Lighting problems

Willdan investigated lighting problems reported by the staff of ______, where approximately 3 ballasts and 16 lamps are failing each week. After finding several instances of incompatible equipment, Willdan recommends a comprehensive review of the installed lighting.

Figure 8. Sample electrical circuit with the multifunction fixture (lighting fixture type A)

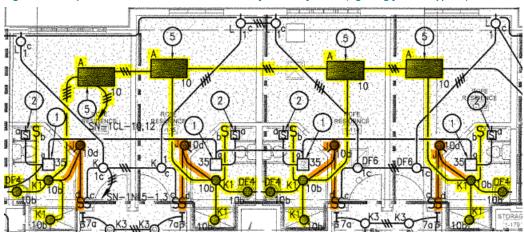
The specified wiring included the multifunction fixture on a circuit with LED step lights (type J), CFL recessed downlight fixtures (type K1), and CFL vanity fixtures (type DF4). The specified switches were nondimming (see figure 8; drawings 1.E3.1, 1/20/12, and 1.E3.3, 9/30/11). Also, the specified wiring included a low voltage lighting controller for the multifunction fixture and switches on the patient pillow speaker (see figure 9; drawing 1.E0.2, 1/20/12).

Source: Detail of rooms 1-113 to 1-116 on the lighting plan, drawing 1.E3.1, 1/20/12. Highlights are added to show circuit SN-1CL-10. About fixture type A, sheet note 5 says, "Refer to wiring diagram 1/1.E0.2 for switching of patient lighting system." For the wiring diagram, see figure 9.
